CIELO VISTA BUSINESS PARK
PRELIMINARY OVERALL AREA DEVELOPMENT PLAN
INGRAM RIDGE SUBDIVISION

POADP # 615

Cielo Vista Business Park

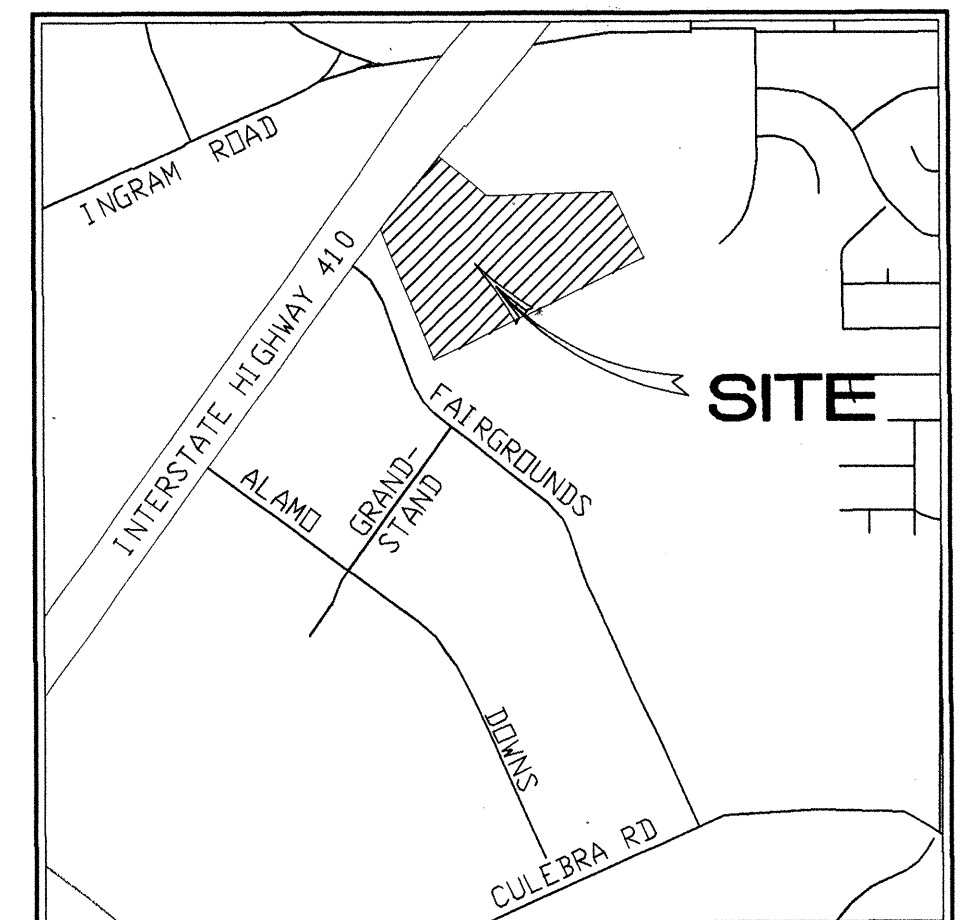
The City Staff Development Review Committee has reviewed Cilo Vista Subdivision Preliminary Overall Area Development Plan # 615. Please find enclosed a signed copy for your files. Although your plan was accepted, please note the following:

- Based on the topography, a Flood Plain Study and drainage review will probably be required during the platting process.
- In consideration of public safety and convenience, excessive grades by reason of topography should be avoided in street layouts and arrangements.
- Access and R.O.W. issues along State facilities will need to be resolved with the Texas Department of Transportation (TXDOT). For information about these requirements contact TXDOT at 615-5814.
- This development will need to comply with tree preservation ordinance #85262. For information about these requirements you can contact Building Inspections at 207-7102.
- It will be expected that you will plat all of the property depicted in your POADP, to include: floodpains, drainage areas and open space.
- I would encourage you to work closely with the school district, so that they can plan accordingly.

drainage easements will be required
and will be address during the platting process

- tree
- slope note
- vehicular non access
~~at segment~~ ~~at~~ ~~Wacos~~
(on map)
- ~~to cut~~ • add vehicular
- TIA

one ft non access easement
@ Wacos cul-de-sac
@ the time of platting

COMMENTS ELIZABETH - I ADDED THE WORD
"VEHICULAR" TO THE 1' NON-ACCESS
ESMT. THE AREA ACREAGE OF LOT 2 ALSO
CHANGED 16.35 AC - 17.02 AC
